WMGT DOCUMENT REVIEW SHEET

ROCKWELL HANFORD OPERATIONS #: SD-BWI-TP-039

DOCUMENT: Integrity Testing Plans for Selected Hanford Site
Monitoring Wells

REVIEWER: Williams and Associates, Inc.

FIGURE 2. Typical Configuration of Straddle Packer System as Used for Integrity Testing.

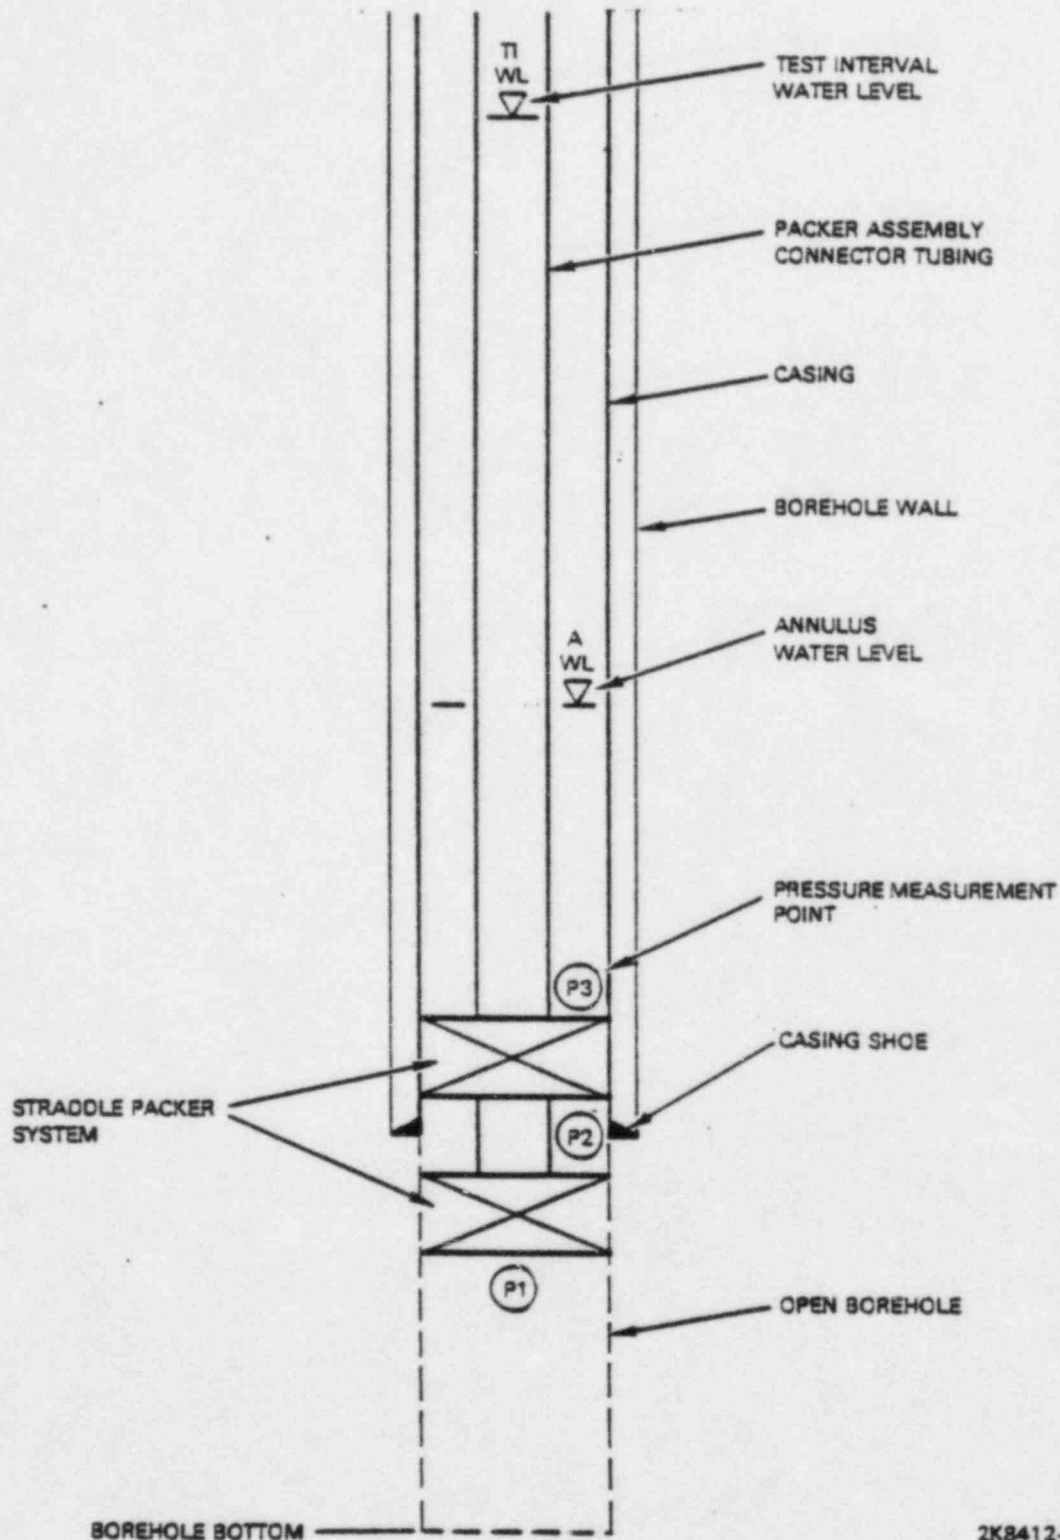
The above described deficiency in this report can be noted under Item 6 of "Expected Results" on page 14 of the document under review. This item refers to the integrity testing of borehole DB-1. This item states that the pressure remains constant in interval P2 (see attached figure) subsequent to stressing the interval monitored by P2. We wish to point out that a constant pressure is not possible if the basalt has a finite hydraulic conductivity; some pressure bleed-off into the finite hydraulic conductivity basalt must occur. However, the hydraulic conductivity may be so low that the pressure bleed-off from the stress will be minimal over the test period in which case the pressure may appear to be constant when in reality it is not.

The point that the basalt may have a finite hydraulic conductivity is not considered adequately in the discussion on page 14 under "Possible Results", Item 5a, 6a, and 6c. Item 5a assumes that a pressure change in transducer P2 does not occur although a pressure change does occur in the annulus (P3) after the annulus is stressed. The absence of pressure change in interval P2 is stated as being indicative of a casing leak. This conclusion is not warranted because flow could occur around the packer into the interval P2 without detection by the transducers. Pressure build-up would not occur in interval P2 because the hydraulic conductivity of the basalts would allow the dissipation of the influx of water without a concomitant, measurable increase in pressure. This point is especially relevant due to the moderate sensitivity of the transducers to small pressure changes. The report under review does not describe the amount of head (pressure) changes which will be induced on the units being tested.

Item 6a (page 14) considers the stressing of the interval monitored by transducer P2. Item 6a assumes that a constant pressure detected by transducer P1 is indicative of a good straddle packer seal. As noted above, fluid could move into the P1 zone without causing a concomitant pressure change. The high hydraulic conductivity of the zone could prevent the build-up of pressure at P1. Item 6c makes the same tacit assumption in the description of another possible result of stressing the interval monitored by transducer P2. It is assumed that there is a pressure change in transducer P2 but not in transducer P1. Again, it is possible for fluid to move from transducer P2 to transducer P1 without a measurable pressure increase in transducer P1. The high hydraulic conductivity of the basalt at P1 may allow the dissipation of pressure without causing a measurable pressure change at P1.
